RE: Field issue of LP panel siding not extending over upper top plate and header for floor joists for Lot #111 Manor at Stoney Creek –4409 SW Grindstone Circle Lee's Summit, MO 64082 – Permit # PRRES20216314

LP Panel Siding not extending to upper top plate:

FIGURE R602.10.6.4 METHOD CS-PF—CONTINUOUSLY SHEATHED PORTAL FRAME PANEL CONSTRUCTION

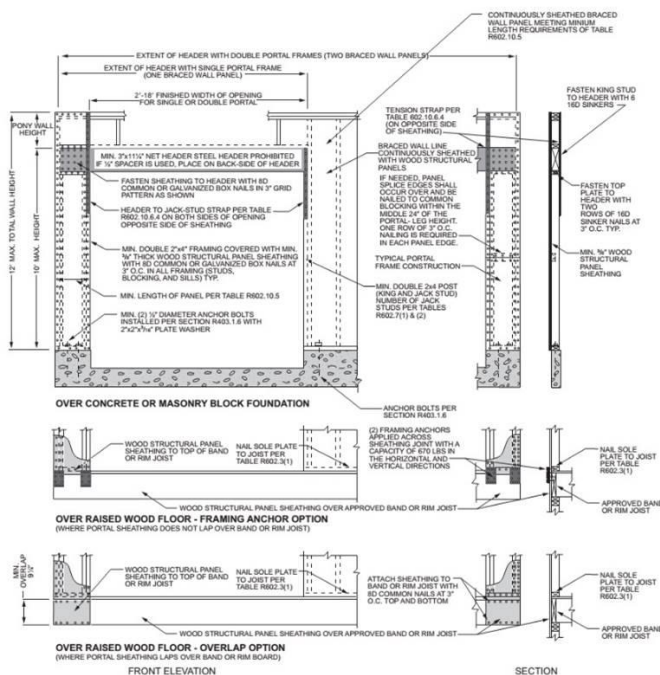
- LP Panel Siding does not extend to the upper top plate at exterior dining, great room and bedroom #1 surrounding covered deck.

At exterior dining wall:

- Install (2) #2 DFL 2x12 continuous header corner to corner flush under double top plate at dining for CS-PF.
- Attach siding with nail pattern as specified in IRC figure below:
